**SERVICE BULLETIN**

**APPLICABILITY:** 2017MY Impreza 4Dr. (Sedan) Models

**NUMBER:** 12-235-18

**SUBJECT:** Trunk Release Difficult to Operate

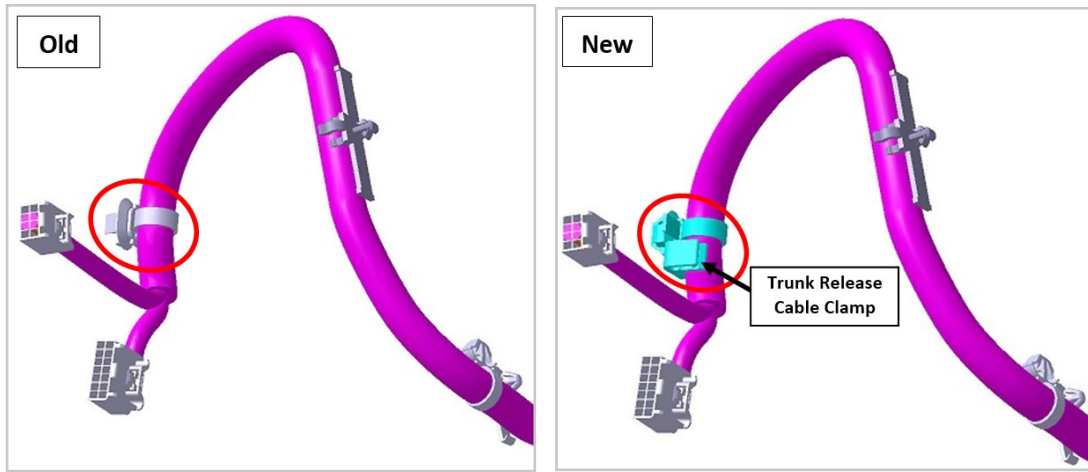
A retaining clamp for the trunk release cable has been added to the new trunk lid cord's retaining clip (it is not serviced separately). The illustrations below show the difference between the old and the new style trunk lid cords.

New Component Name	Part Number	Applicability
CABLE ASSEMBLY- TRUNK LID	57330FL04B	All
CORD TRUNK LID	81811FL00B	w/ Key Start
	81811FL01B	w/ Push Button Start

Illustration “A” shows:

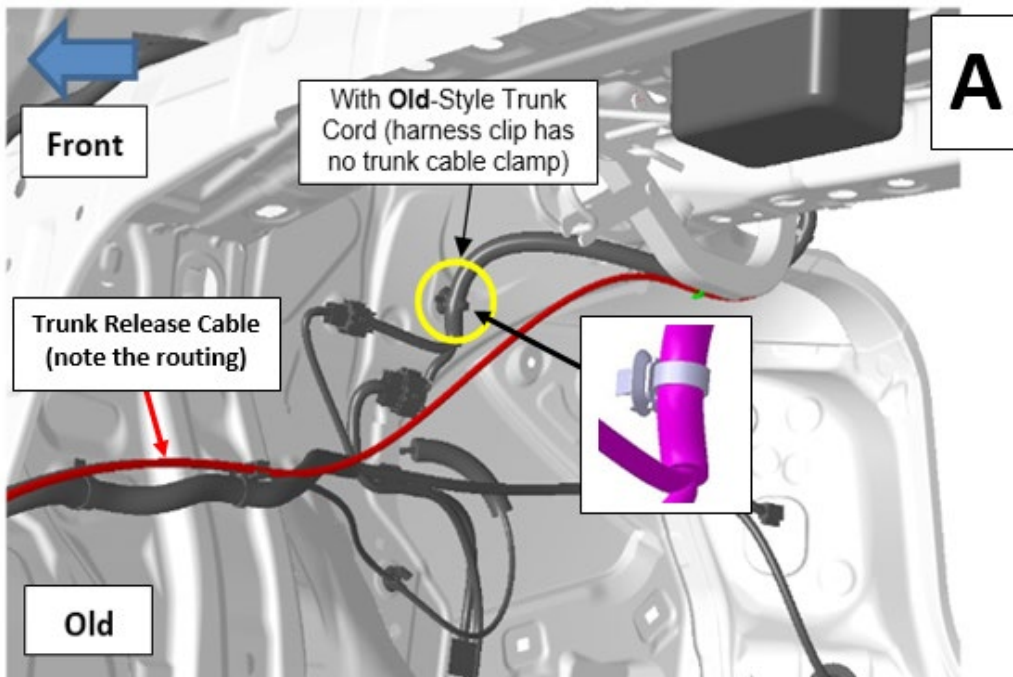
- Trunk release cable routing (red)
- Old-style harness retaining clip with no trunk release cable retaining clamp.

Illustration and photo “B” show:

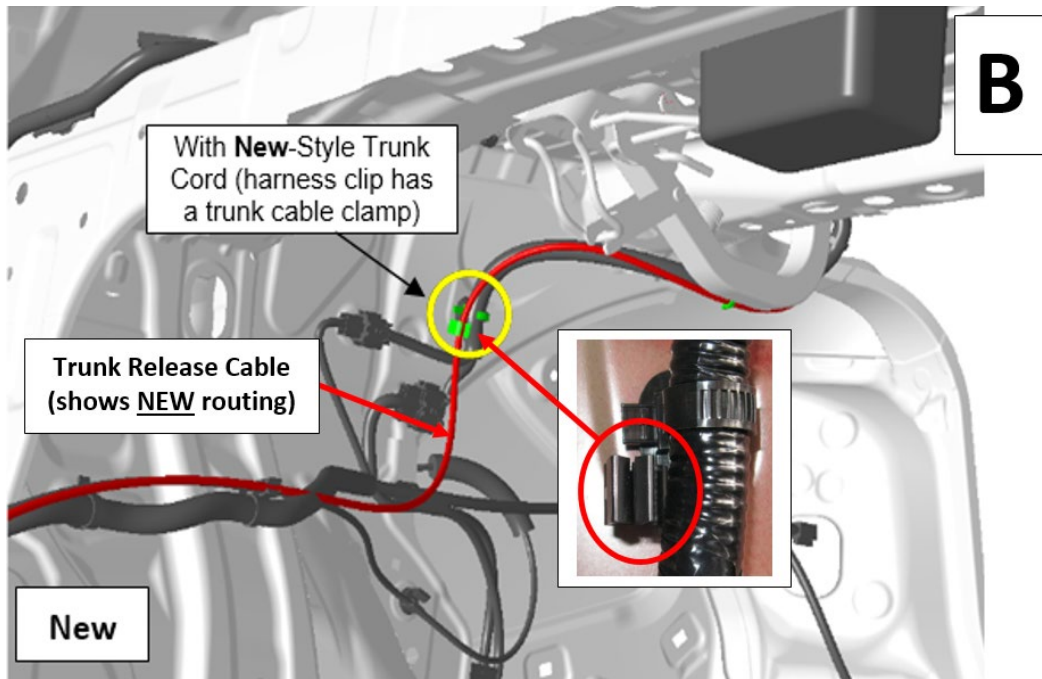
- New-style trunk cord with release cable retaining clamp
- Trunk cable (red) installed with new routing.

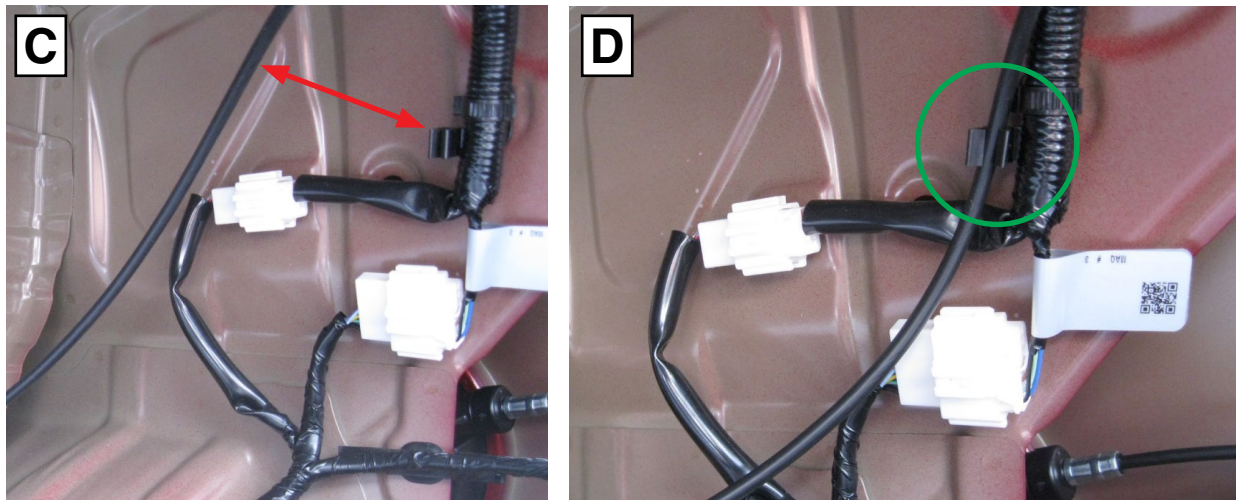
- If inspection reveals the trunk release cable has come loose from the retaining clamp of a vehicle equipped with the new-style deck lid cord (Photo C), clip it back into place and retest for proper operation before proceeding with cable replacement.

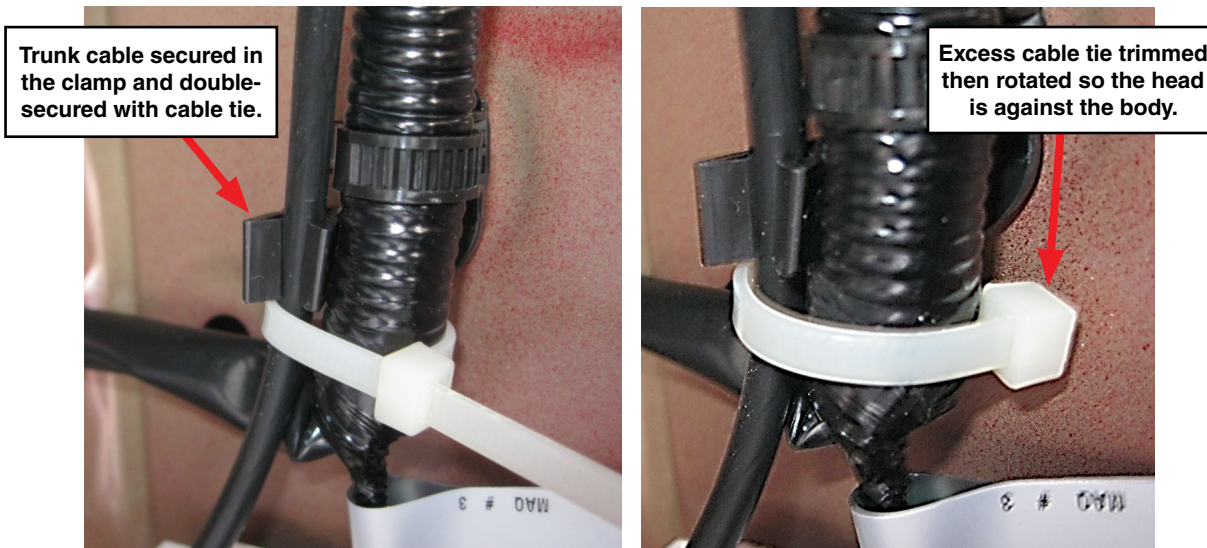
**VERY IMPORTANT:** The trunk release cable **MUST ALWAYS** be secured to the trunk lid cord **REGARDLESS** if a new or old-style cord (harness retaining clip has no cable retaining clamp) is being used. Use a medium-sized (8-10mm wide) cable tie placed at the trunk lid cord retaining clip and trim off the excess as shown below.

- If securing the trunk release cable to an old-style trunk lid cord with a cable tie as shown above resolves the concern, neither the cable or the cord need replacement.
- If securing the cable does not resolve the concern and trunk release cable replacement is required, follow the procedure in the applicable Service Manual.

**REMINDER:** The trunk release cable **MUST** be secured to the trunk lid cord using a cable tie as shown above before reinstalling the trunk area inner trim.
